**CITY OF PORTLAND, MAINE
DEVELOPMENT REVIEW APPLICATION
PLANNING DEPARTMENT PROCESSING FORM
D.R.C. Copy**

new single family Lot 4

**CITY OF PORTLAND, MAINE
SITE PLAN REVIEW (ADDENDUM)
CONDITIONS OF APPROVAL**

MINOR SITE PLAN
AT 63 MURRAY STREET PORTLAND, MAINE
FOR:
WILLIAM DIBIASE

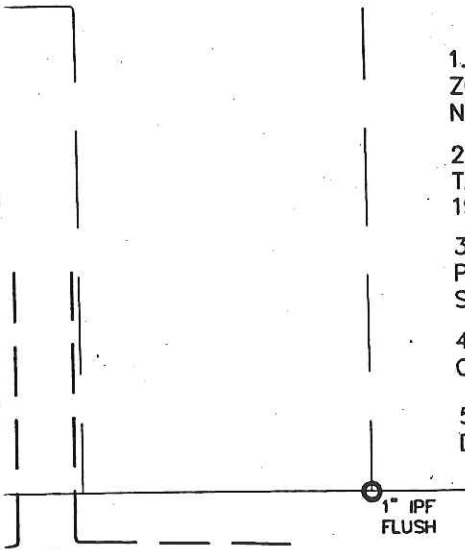
*Ask Trans.
100 yr Flood
clearance*

*CHRIS,
revised plan per
the items you
noticed - elevations
have been changed
12/4/00*

REVISED: 12-03-2000 ELEVATION DATUM, PROPERTY CORNERS SET.
